PCN: V16-001-476103-OA

Product Change Notice

To change the tape & reel pocket dimension from 3.4x3.4mm to slightly bigger 3.6x3.6mm

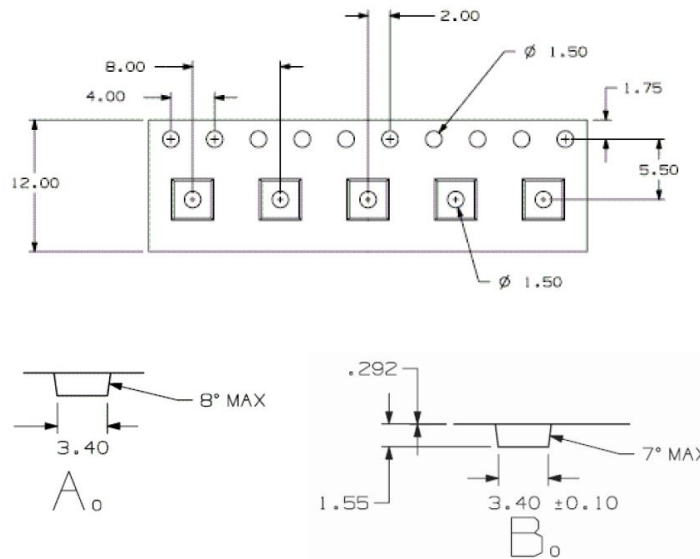
Slightly bigger tape pocket dimension from 3.4x3.4mm to 3.6mmx3.6mm as illustrated below shall not affect the existing customer pick-up tool as the tape pitch remained the same.

A₀ = Change this pocket dimension from 3.4mm to 3.6mm
 B₀ = Change this pocket dimension from 3.4mm to 3.6mm
